# NORTHROP GRUMMAN BUILDING AUC-9 SITE PLAN AMENDMENT

- 1996-6095-07  
MOVE VOLLEY BALL COURT, RELOCATE TREES, RELOCATE STORM SEWER  
ADD EQUIPMENT SCREEN
- 13 ADD PERIMETER FENCING AND PARKING  
LOT ACCESS CONTROL GATES 07.14.2021

SUBMITTAL  
07.19.2021 FOR APPLICATION  
08.19.2021 CITY COMMENTS - 1

PROJECT DESCRIPTION  
PERIMETER FENCING

SHEET NUMBER  
A1.1

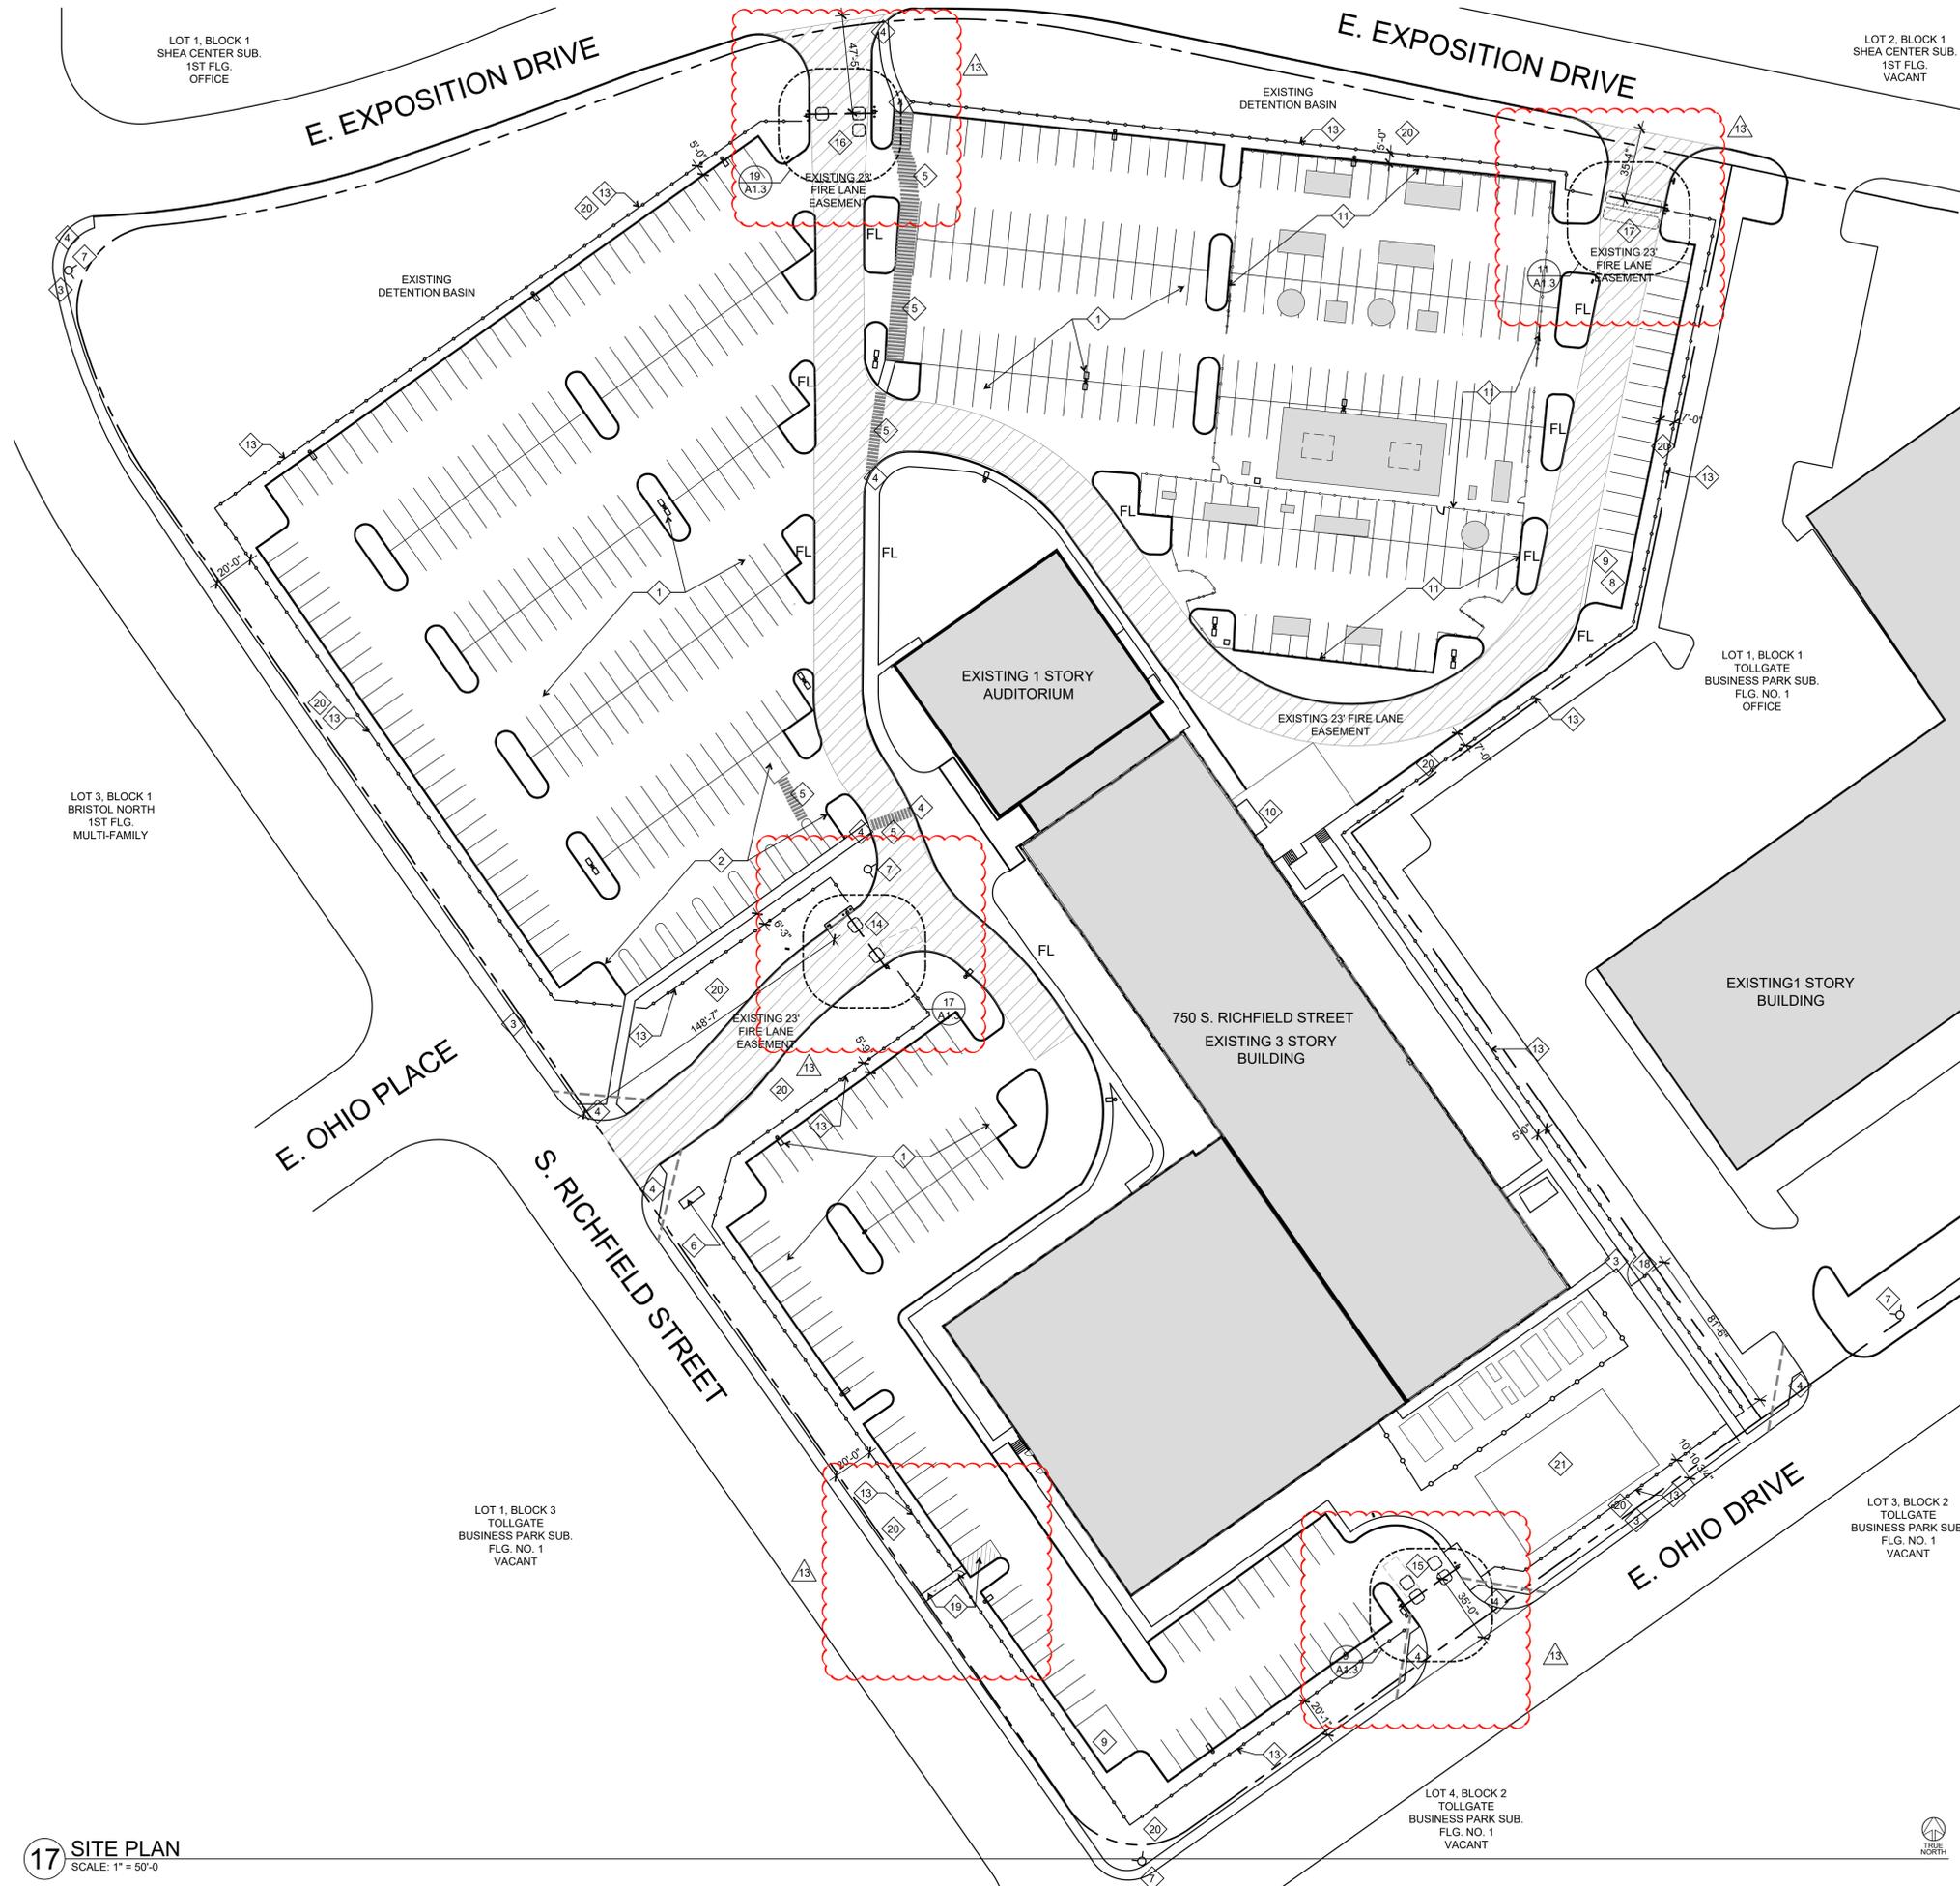
- EXISTING TENANT PROVIDED EQUIPMENT TO REMAIN UNDER TEMPORARY USE PERMIT.
- NEW 8'-0" DECORATIVE METAL SECURITY FENCE. SEE SHEET A1.2 FOR ADDITIONAL INFORMATION.

- (2) NEW ENTRY BARRIER ARM GATES WITH 14' BARRIER ARMS (VERTICAL OPENING OPERATION) AND ENTRY TERMINAL WITH BADGE READER, LICENSE PLATE READER CAMERA, VOIP INTERCOM, APPROVED SIREN OPERATED SENSOR, INTEGRATED KNOX, BOX KEY SWITCH, AND MANUAL RELEASE. REFER TO DETAILS 3/A1.2 AND 7/A1.2 FOR ADDITIONAL INFORMATION.

- (2) NEW EXIT BARRIER ARM GATES WITH 14' BARRIER ARMS (VERTICAL OPENING OPERATION) WITH "FREE EXIT" LOOP, LICENSE PLATE READER CAMERA, APPROVED SIREN OPERATED SENSOR, INTEGRATED KNOX BOX KEY SWITCH, AND MANUAL RELEASE REFER TO DETAILS 3/A1.2, 7/A1.2 AND 11/A1.2 FOR ADDITIONAL INFORMATION.

- (2) NEW ENTRY / EXIT BARRIER ARM GATES WITH 14' BARRIER ARMS (VERTICAL OPENING OPERATION) AND ENTRY TERMINAL WITH LICENSE PLATE READER CAMERA, APPROVED SIREN OPERATED SENSOR, INTEGRATED KNOX BOX KEY SWITCH, AND MANUAL RELEASE. REFER TO DETAILS 3/A1.2 AND 7/A1.2 FOR ADDITIONAL INFORMATION.

- (1) NEW ENTRANCE / EXIT BARRIER ARM GATE WITH 28' BARRIER ARM (VERTICAL OPENING OPERATION) WITH VOIP INTERCOM FOR REQUEST TO ENTER, AND "FREE EXIT" LOOP FOR EXIT, LICENSE PLATE READER CAMERA, APPROVED SIREN OPERATED SENSOR, INTEGRATED KNOX BOX KEY SWITCH, AND MANUAL RELEASE. REFER TO DETAILS 3/A1.2 (SIM), AND 7/A1.2 (SIM), FOR ADDITIONAL INFORMATION.

- NEW 10'-0" LOCKABLE MANUAL SWING GATE TO MATCH METAL FENCE. SEE SHEET A1.2 FOR ADDITIONAL INFORMATION.
- NEW 4'-0" KNOX LOCKABLE MANUAL SWING GATE TO MATCH METAL FENCE AND NEW 4'-0" SIDE CONCRETE SIDEWALK, MARK PARKING SPOTS AS "NO PARKING" AND CROSS HATCH STRIPING. SEE SHEET A1.2 FOR ADDITIONAL INFORMATION.

- EXISTING LANDSCAPING TO REMAIN UNDISTURBED EXCEPT WHERE EXISTING INTERFERES WITH INSTALLATION OF FENCE OR ENTRY / EXIT GATES. REPLACE EXISTING DISTURBED LANDSCAPING WITH NEW AND INSTALL NEW LANDSCAPING TO MATCH CITY OF AURORA REQUIREMENTS FOR PARKING LOT SCREENING.

SHEET NUMBER	
A1.3

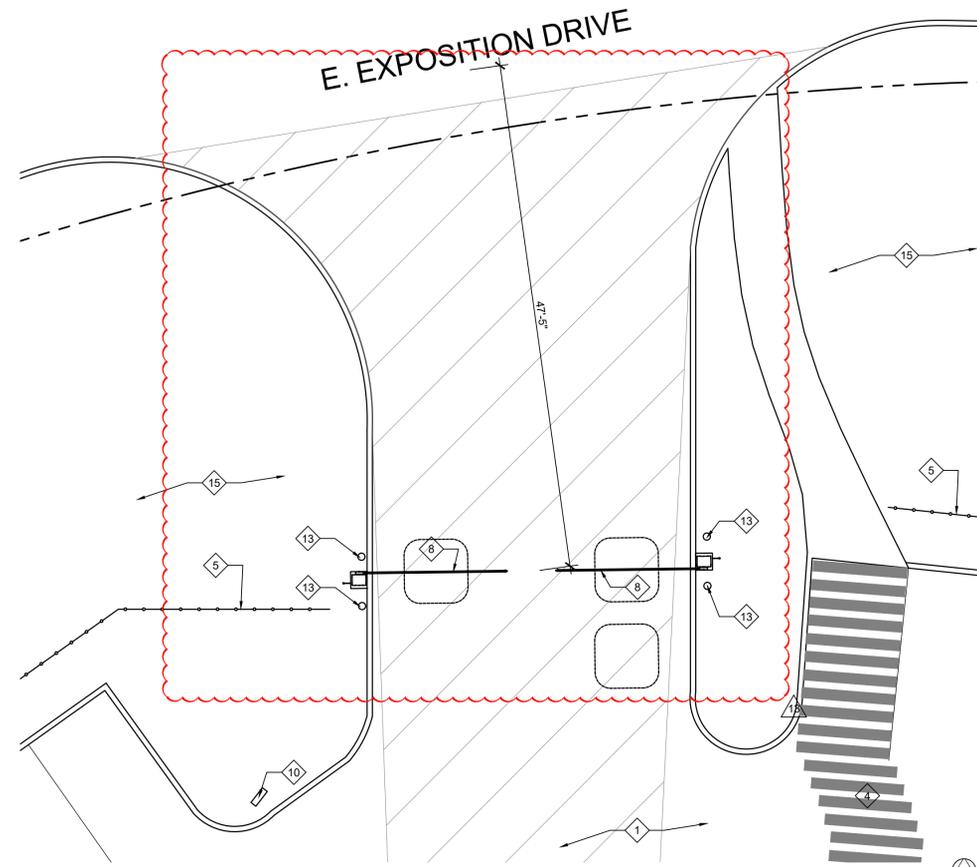
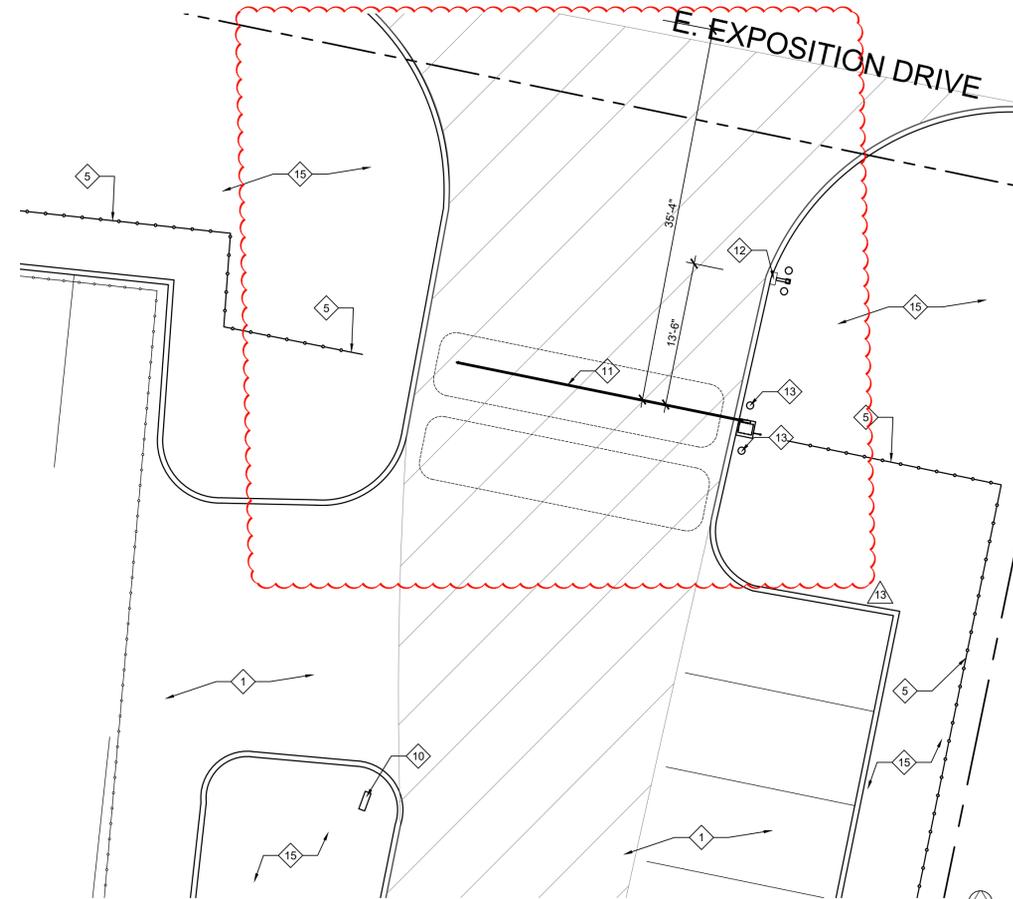
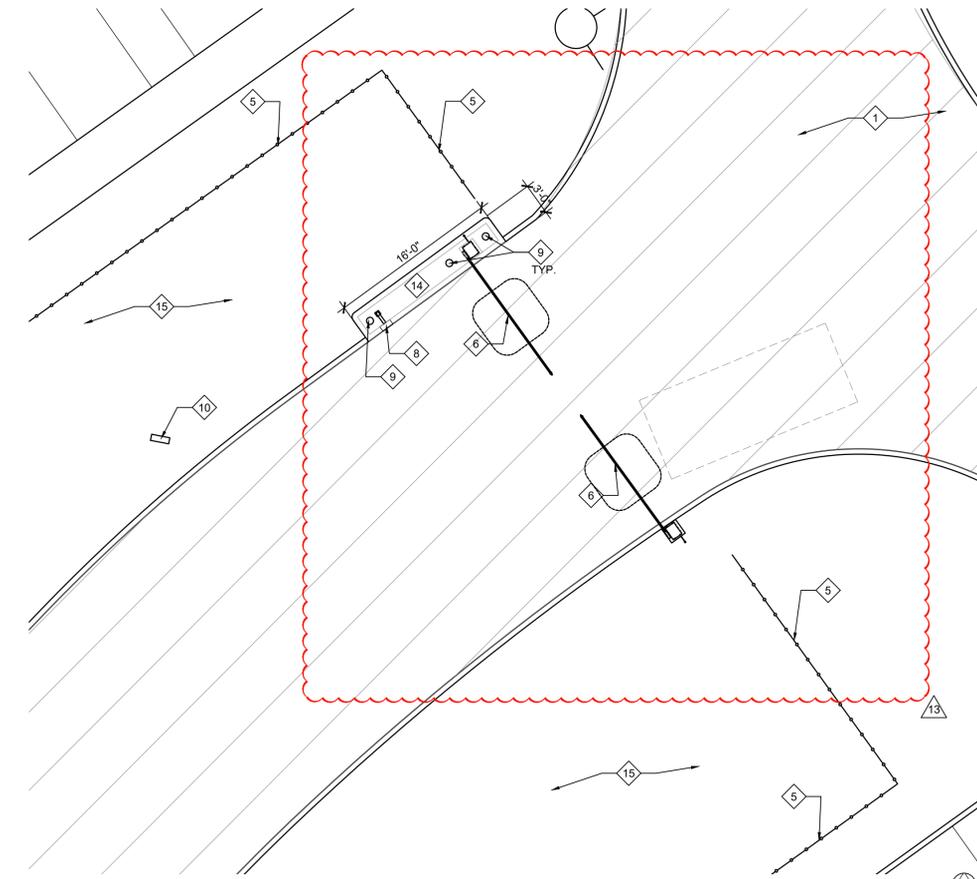
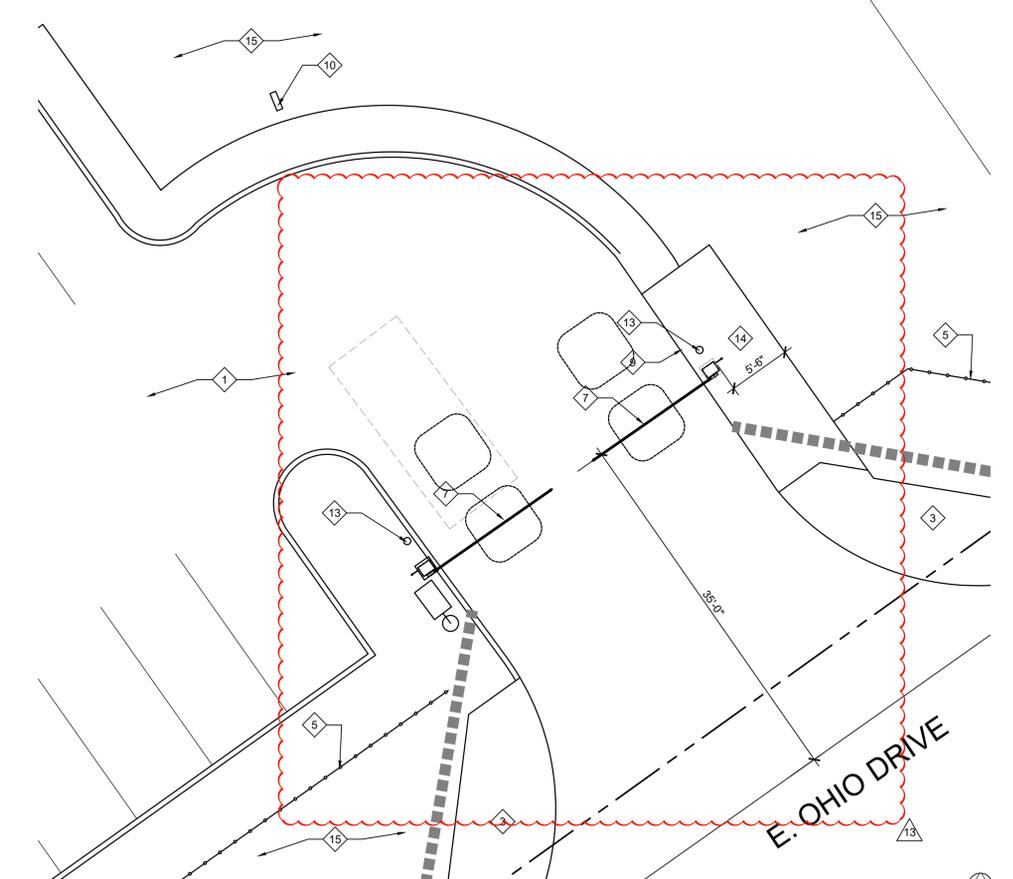
5. NEW 8'-0" DECORATIVE METAL SECURITY FENCE EQUAL TO AMERISTAR MONTAGE COMMERCIAL CLASSIC PROVIDED AND INSTALLED BY G.C. SEE 7/A1.2 FOR FENCE AND GATE DETAILS.

6. (2) NEW ENTRY BARRIER ARM GATES WITH 14' BARRIER ARMS (VERTICAL OPENING OPERATION) AND ENTRY TERMINAL WITH APPROVED SIREN OPERATED SENSOR, INTEGRATED KNOX BOX KEY SWITCH, AND MANUAL RELEASE EQUAL TO HYSECURITY STRONG ARM PARK DC 14 BARRIER GATE OPERATOR AND VEHICLE DETECTION LOOP PROVIDED AND INSTALLED BY G.C. REFER TO DETAILS 3/A1.2 AND 7/A1.2 FOR ADDITIONAL INFORMATION.

7. (2) NEW EXIT BARRIER ARM GATES WITH 14' BARRIER ARMS (VERTICAL OPENING OPERATION) AND ENTRY TERMINAL WITH APPROVED SIREN OPERATED SENSOR, INTEGRATED KNOX BOX KEY SWITCH, AND MANUAL RELEASE EQUAL TO HYSECURITY STRONG ARM PARK DC 14 BARRIER GATE OPERATOR. "FREE EXIT" LOOP, AND VEHICLE DETECTION LOOP PROVIDED AND INSTALLED BY G.C. REFER TO DETAILS 3/A1.2, 7/A1.2 AND 11/A1.2 FOR ADDITIONAL INFORMATION.

8. (2) NEW ENTRY / EXIT BARRIER ARM GATES WITH 14' BARRIER ARMS (VERTICAL OPENING OPERATION) AND ENTRY TERMINAL WITH APPROVED SIREN OPERATED SENSOR, INTEGRATED KNOX BOX KEY SWITCH, AND MANUAL RELEASE EQUAL TO HYSECURITY STRONG ARM PARK DC 14 BARRIER GATE OPERATOR. "FREE EXIT" LOOP, AND VEHICLE DETECTION LOOP PROVIDED AND INSTALLED BY G.C. REFER TO DETAILS 3/A1.2 AND 7/A1.2 FOR ADDITIONAL INFORMATION.

11. (1) NEW ENTRANCE / EXIT BARRIER ARM GATE WITH 28' BARRIER ARM (VERTICAL OPENING OPERATION) WITH VOIP INTERCOM FOR REQUEST TO ENTER, AND "FREE EXIT" LOOP FOR EXIT. APPROVED SIREN OPERATED SENSOR, INTEGRATED KNOX BOX KEY SWITCH, AND MANUAL RELEASE EQUAL TO HYSECURITY STRONG ARM 28. REFER TO DETAILS 3/A1.2 (SIM.) AND 7/A1.2 (SIM.) FOR ADDITIONAL INFORMATION.

12. VOIP INTERCOM FOR REQUEST TO ENTER PROVIDED AND INSTALLED BY TENANT. CONDUIT BACK TO SECURITY OFFICE IN MAIN BUILDING BY G.C.
13. 8" Ø CONCRETE FILLED PAINTED PIPE BOLLARD PROVIDED AND INSTALLED BY G.C. REFER TO DETAILS 15/A1.2 AND 19/A1.2 FOR ADDITIONAL INFORMATION.

14. NEW CONCRETE PAD / SIDEWALK PROVIDED AND INSTALLED BY G.C. MODIFY EXISTING SIDEWALKS WHERE REQUIRED.
15. EXISTING LANDSCAPING TO REMAIN UNDISTURBED EXCEPT WHERE EXISTING INTERFERES WITH INSTALLATION OF FENCE OR ENTRY / EXIT GATES. REPLACE EXISTING DISTURBED LANDSCAPING WITH NEW AND INSTALL NEW LANDSCAPING TO MATCH CITY OF AURORA REQUIREMENTS FOR PARKING LOT SCREENING.
